Preferred Project Report

For:
Proposed Six Storey Commercial Building with
Two Storey Basement Car Park, Associated
Plant, Signage and Subdivision of Lot 8b

At:
8b Murray Rose Avenue,
Sydney Olympic Park

Application Number: MP10_0214

Public Domain Interface Plan

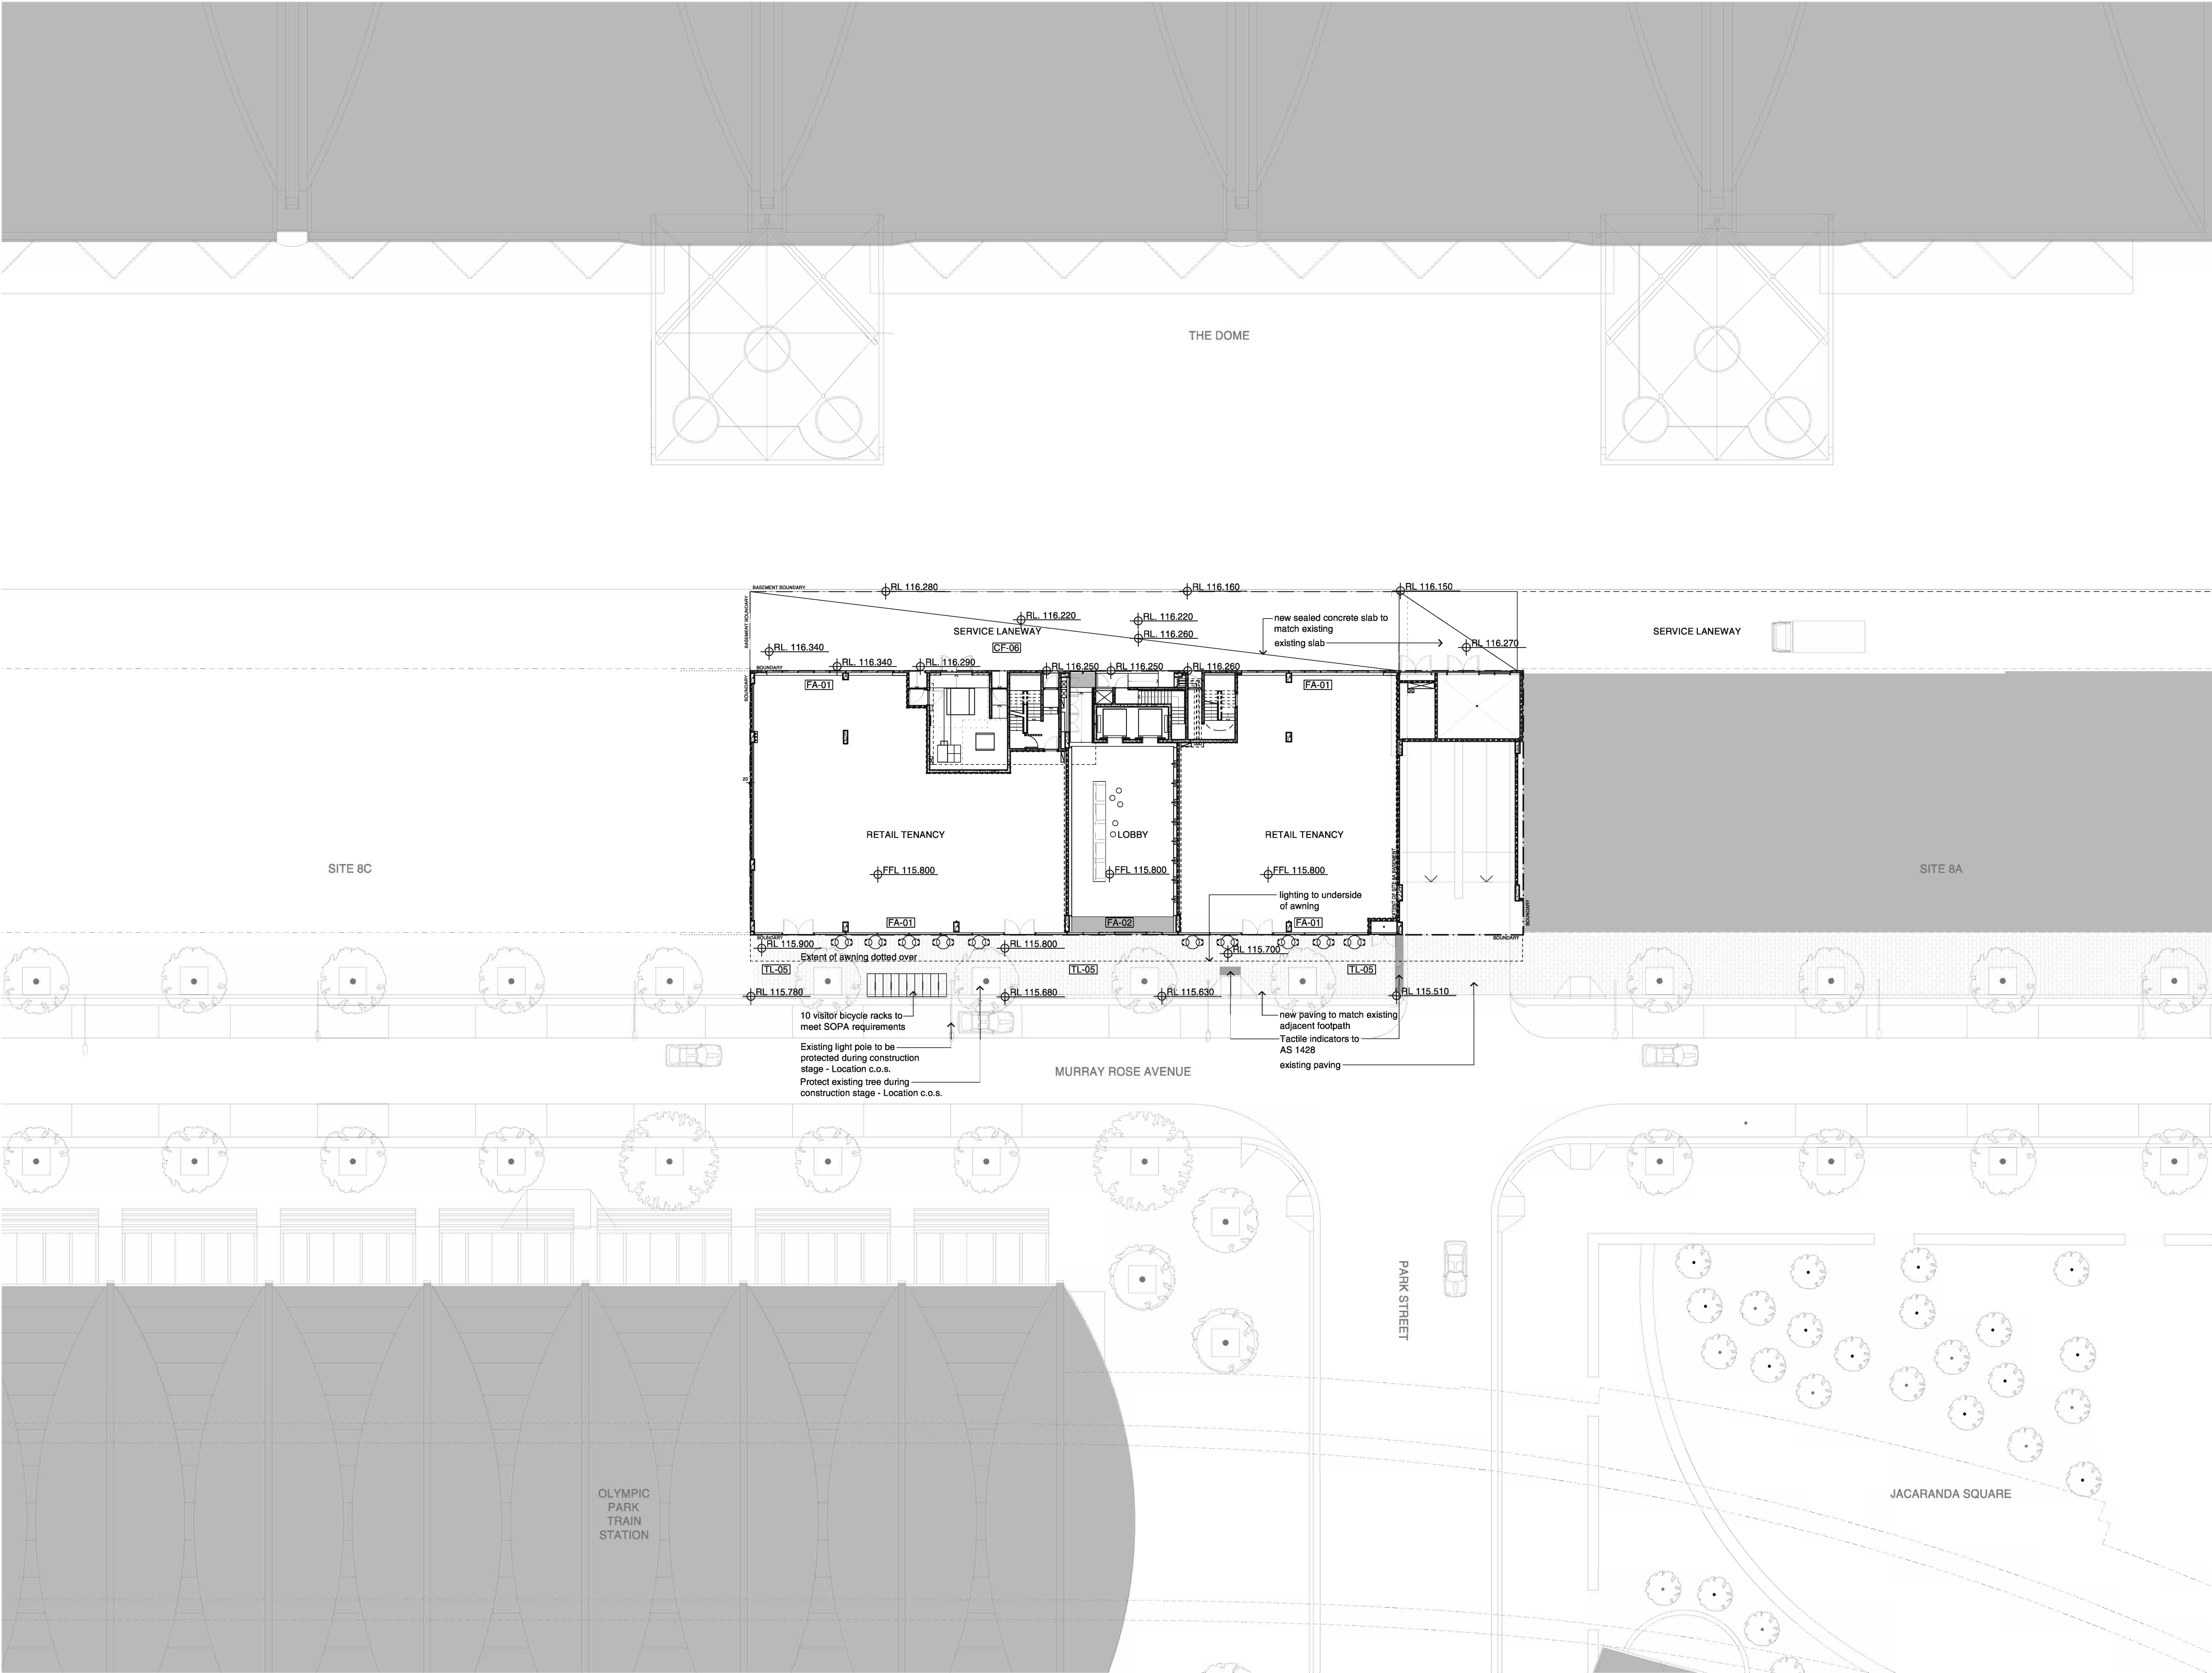
2.3 Public Domain A detailed Public Domain Interface Plan (PDIP), coordinating external treatments, levels, furniture, egress etc. for both frontages of the building, is yet to be provided. The PDIP (at minimum 1:200 scale) should provide details of all material & finishes, siting of street furniture, public lighting, access elements and any proposed commercial outdoor seating zones. The PDIP is to ensure coordinated finished footpath levels between Murray Rose Avenue and the proposed development.	Refer to the attached PDIP Drawing A01.10 [02]

The proposed development has provided 10 bicycle parking spaces for visitors on Ground Floor footpath along Murray Rose Avenue. Please refer to attached Drawings A01.10[02] and A03.00[09].

Site 8B Commercial Building
Sydney Olympic Park
Ground Level Plan

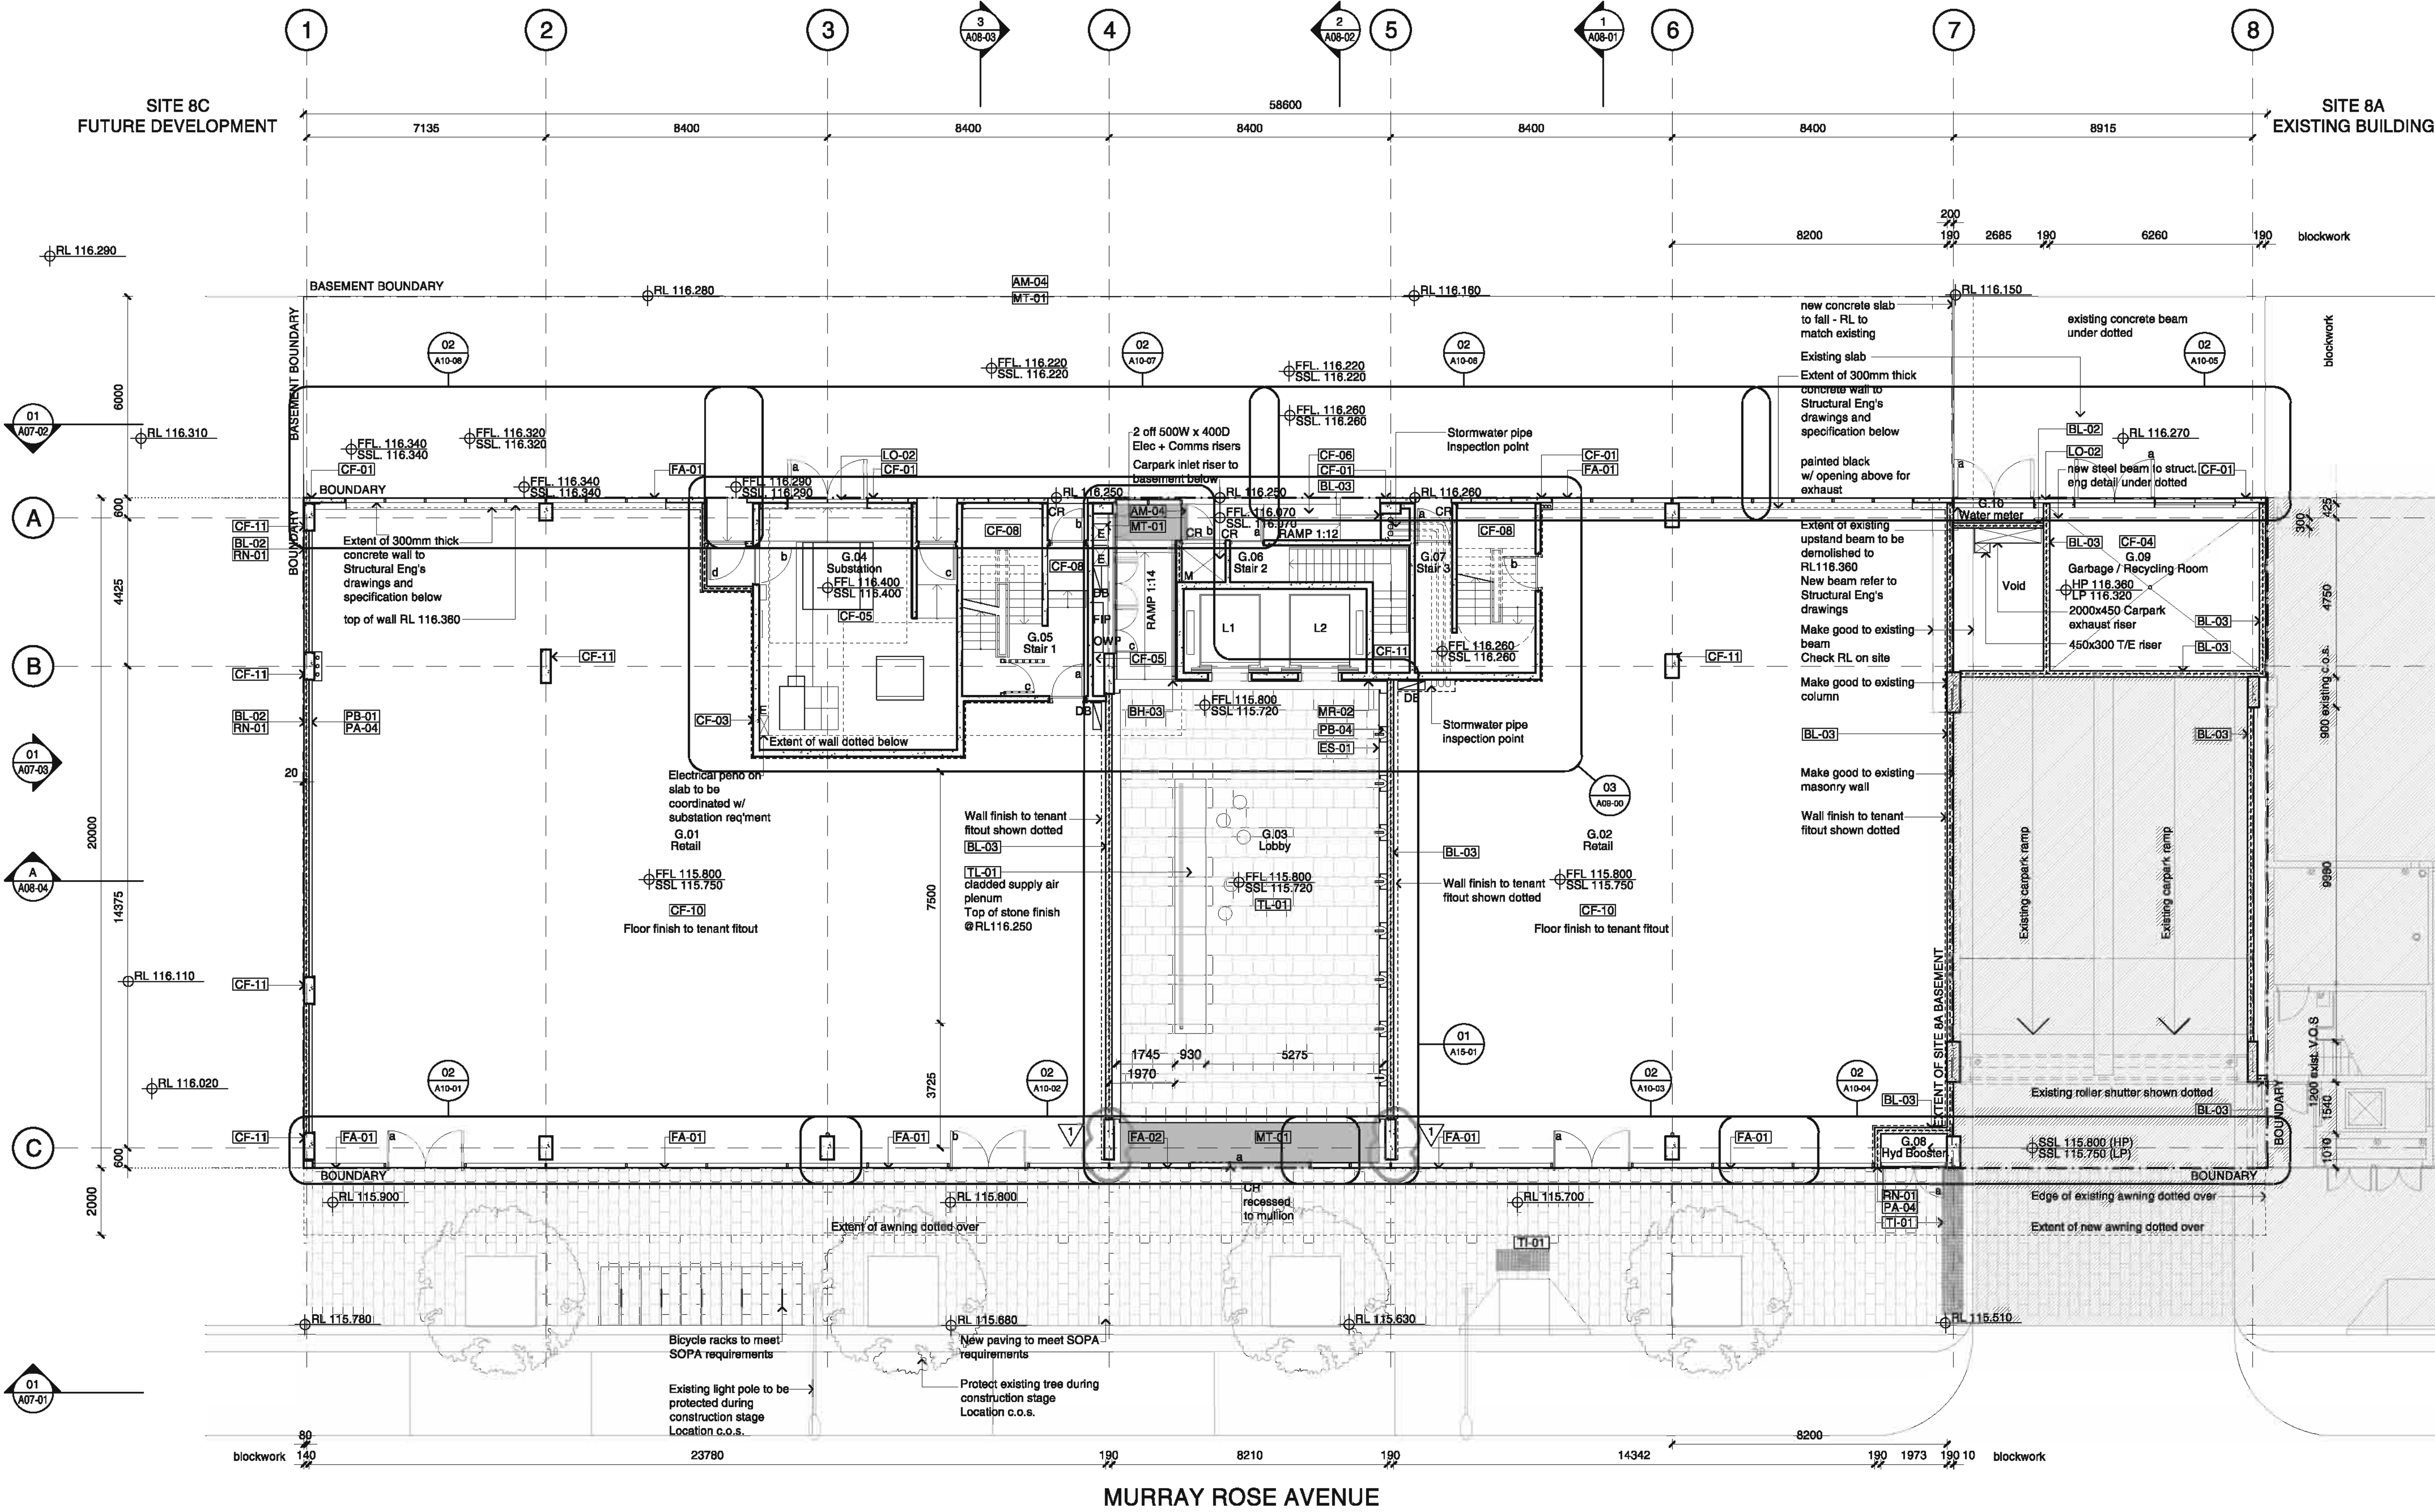
Bicycle Parking The proposed development should provide an additional eight (8) bicycle parking spaces for visitors as required by MP 2030.	The proposed development has provided 10 bicycle parking spaces for visitors on Ground Floor footpath along Murray Rose Avenue. Please refer to attached Drawings A01.10 [02] and A03.00 [09].

Ground floor servicing Access to waste management area at the rear of the building via the lobby will result in unacceptable amenity impacts on the lobby and on building presentation overall. The lift and core design could adjusted to include a double sided	Transfer of waste to Garbage Recycling Room at the rear of the building shall be managed after business hours and will eliminate unacceptable amenity impacts on the lobby. Retail tenancies waste management is provided with direct access to rear lane through stairwell at ground level. Future retail

- Ramp and stairs have been removed from main foyer, providing level access from Murray Rose Avenue;
- Ramp relocated beside lift core and egress to the service land has been revised;
- Proposed substation room has been increased due to infrastructure requirements. This has resulted in a slight reduction in retail floor space;

Transfer of waste to Garbage Recycling Room at the rear of the building shall be managed after business hours and will eliminate unacceptable amenity impacts on the lobby. Retail tenancies waste management is provided with direct access to rear lane through stairwell at ground level. Future retail tenants would also be able to provide access to rear of the building by creating a doorway with ramp or steps at rear shopfronts. Hence, there will not be any unacceptable impacts on the lobby. Please refer to Drawing A03.00[09].
